**TOWN OF WEST NEWBURY
PLANNING BOARD
Tuesday February 20th, 2024 7:00 p.m.
AGENDA**

**Re: Definitive Subdivision Plan - Peer Review #01
Eagle Nest
125 River Road
West Newbury, Massachusetts 01985**

**Re: Interim As-Built – Definitive Subdivision
Major Boyd Drive
(F.K.A. 519 Main Street or Deer Run Lane)
West Newbury, Massachusetts**

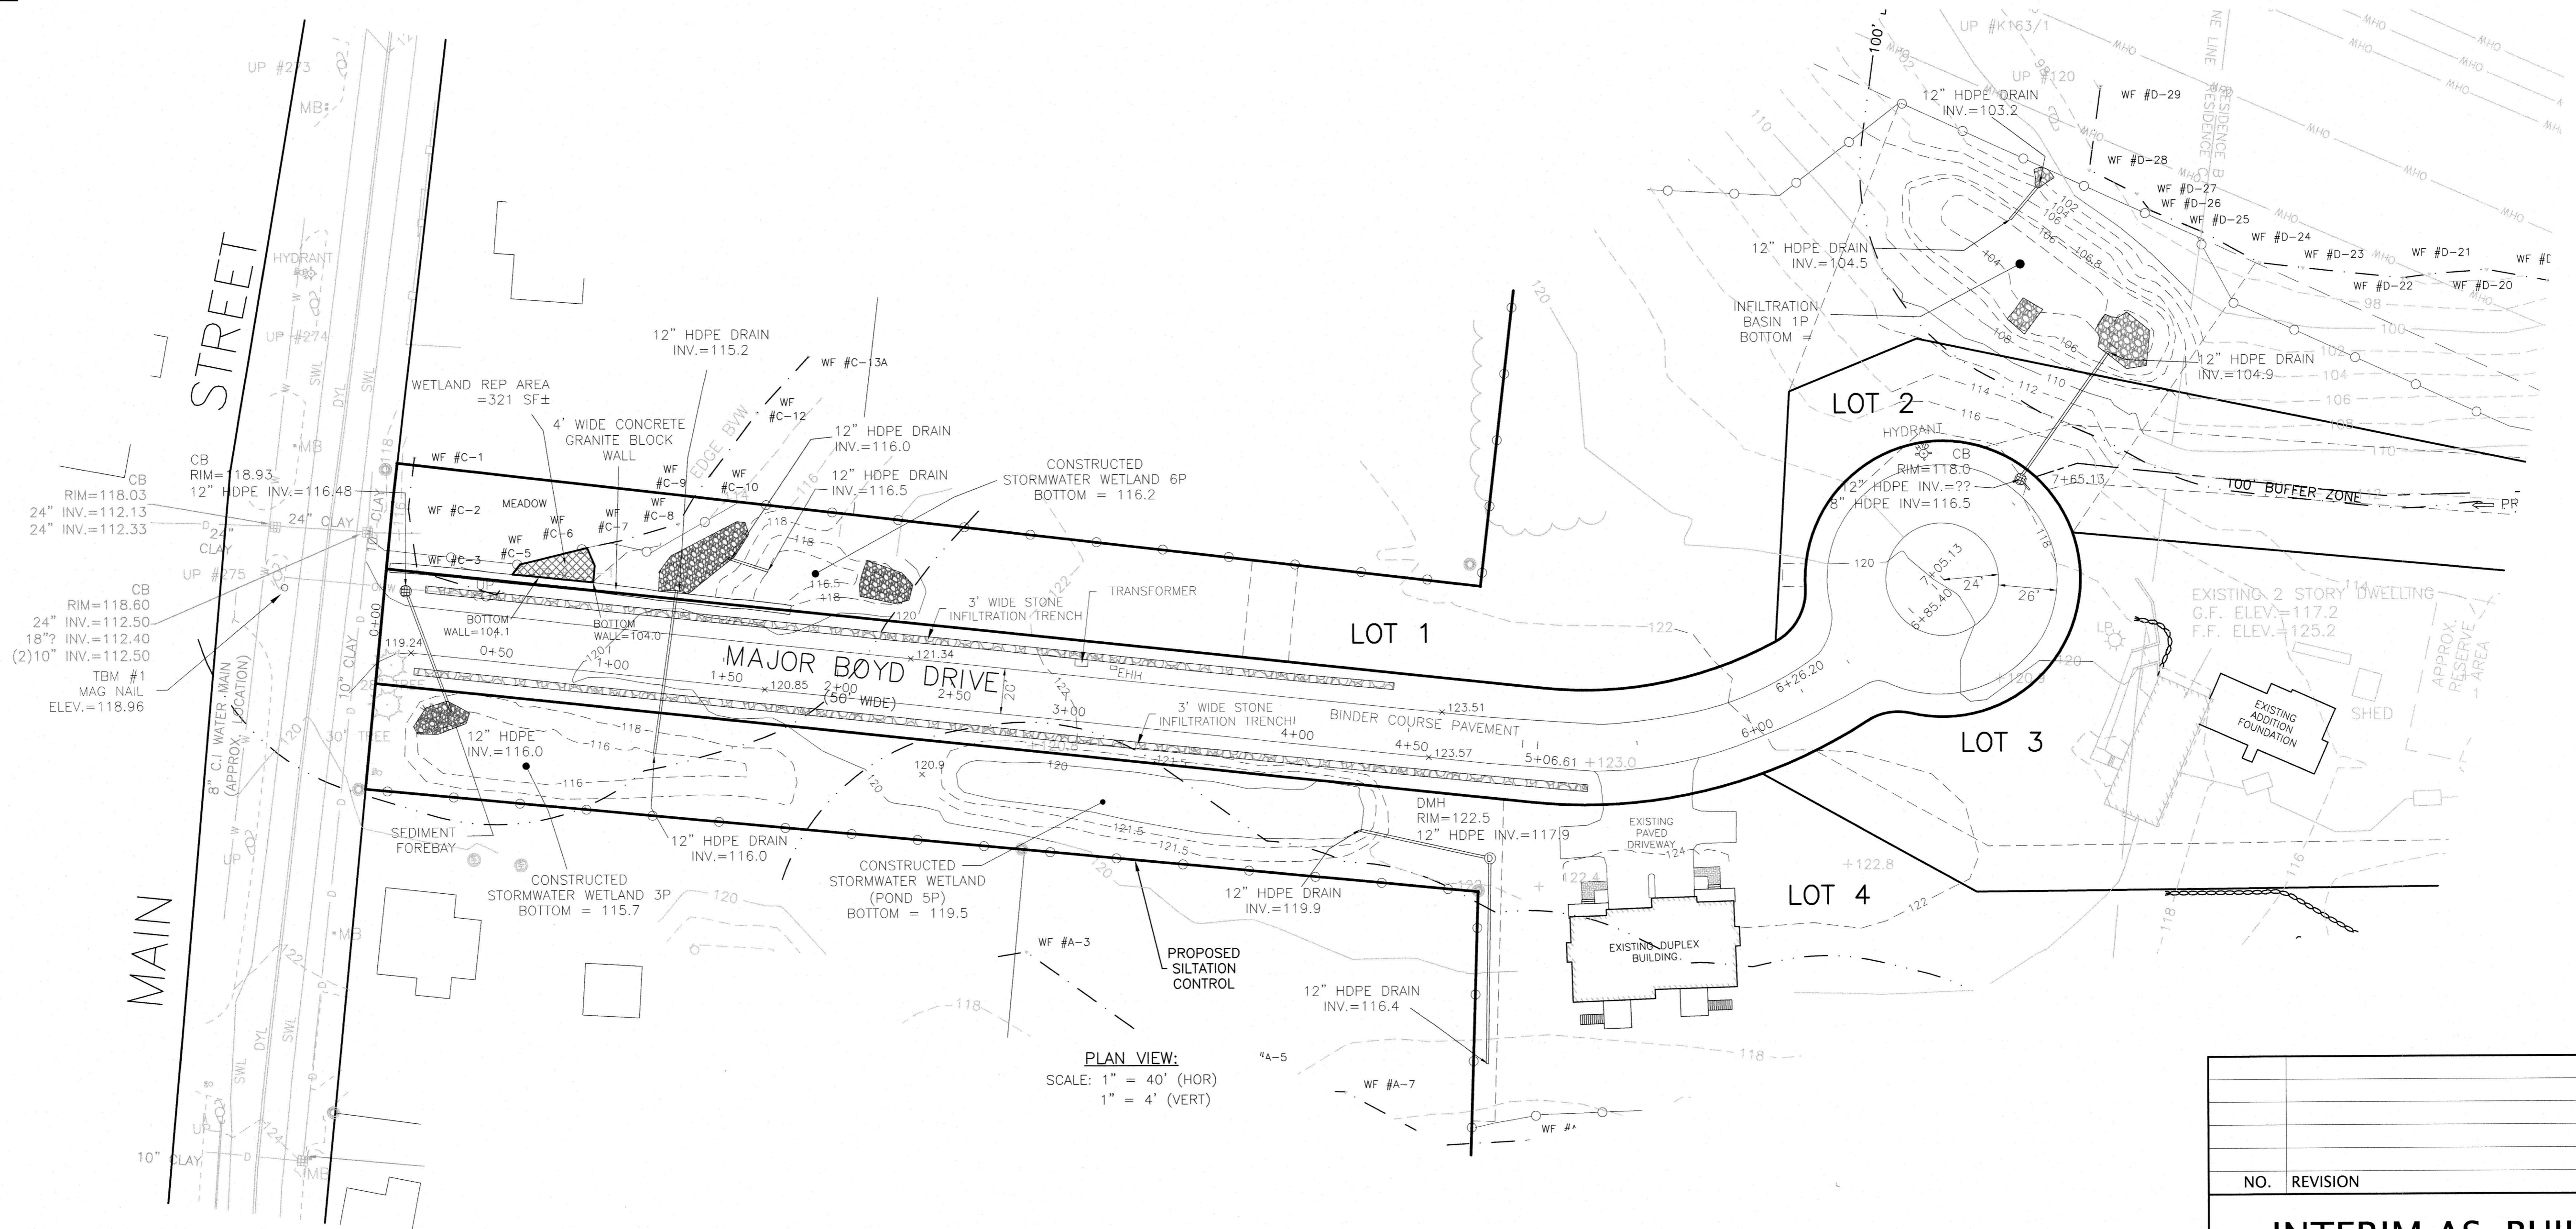
- The location, size and material of the water main and service connections should be shown on the plan;
- The locations of any water gate valves, curb stops, shutoffs, etc. should be shown on the plan;

- The locations of the new etc. lines should be shown on the plan;
- The depth of the stone infiltration trenches should be noted on the plan;
- The locations of the inspection ports in the infiltration trenches should be shown on the plan;

- The top of berm elevations for the constructed wetlands should be noted on the plan;
- The bottom elevation and the berm elevation for Pond 1P, should be shown on the plan;

- The bottom elevation and the berm elevation for the Sediment Forebay at Pond 1P should be shown on the plan;
- The width and elevation of the spillway between the Sediment Forebay and Pond 1P should be shown on the plan;

- The twelve (12) inch HDPE invert in the catch basin, near Pond 2P should be shown on the plan;
- The rip rap apron at the twelve (12) inch pipe outlet on Lot 4 should be shown on the plan;

- A spot grade for the high point of the roadway around station 4+75, should be shown on the plan;
- There is a note referring to ‘proposed siltation fence’ that should be removed from the plan;
